ENCLOSURES:
Proposed Changes to Tech Specs for the Nine Mile Point Unit # 1 (Change # 1 & #2) W/Attached Figs 3.1.7a, 3.1.7b, 3.1.7c & 3.1.7d.

Re: Nine Mile Point Unit 1
AEC Docket No. 50-220

Nine Mile Point Unit 1

Proposed Changes to Technical Specifications

FIGURE 3.1.7.a MAXIMUM ALLOWABLE AVERAGE PLANAR LHGR
APPLICABLE TO FUEL TYPE INITIAL CORE

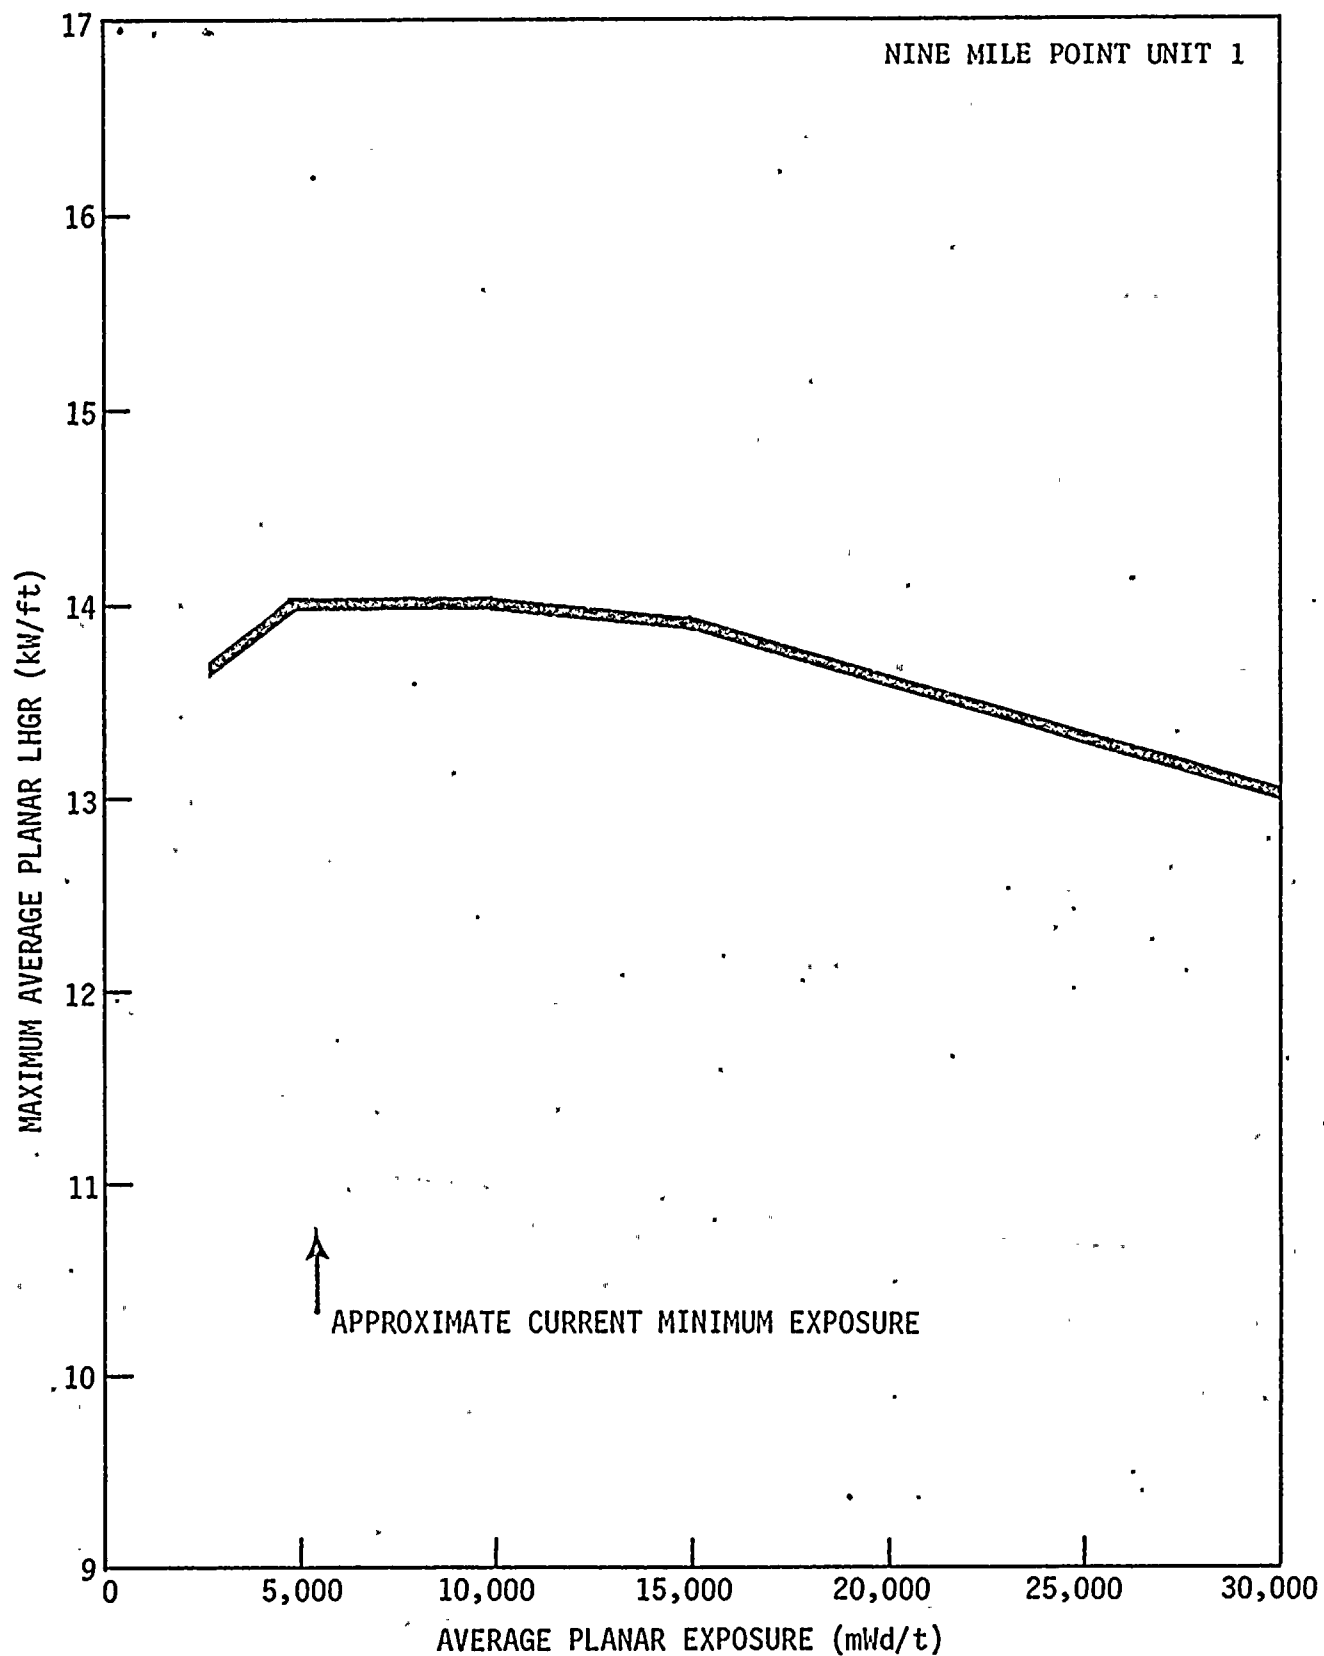
Delete Figure 3.1.7 and replace with the attached Figures 3.1.7a, b, c and d. Under the Limiting Condition for Operation 3.1.7, delete the phrase in the last sentence in paragraph a. of the Specification "Figure 3.1.7" and replace with the phrase Figures 3.1.7a, b, c and d.

Replace the third through sixth paragraphs of the Bases 3.1.7a with the following: "The maximum average planar LHGR curves for the various fuel types in the core shown in Figures 3.1.7a, b, c and d are based on calculations using the models described in the GE reports NEDO-10735, as modified by the GE reports NEDO-20181 and the GE letter of December 12, 1973, to V. Moore from J. Hinds, 'Plant Evaluation with GEGAP-III.'"

Changes to the maximum average planar LHGR are warranted based on results of further analysis and model development as related to the effects of fuel densification. This additional information is described in GE reports NEDO-20181.
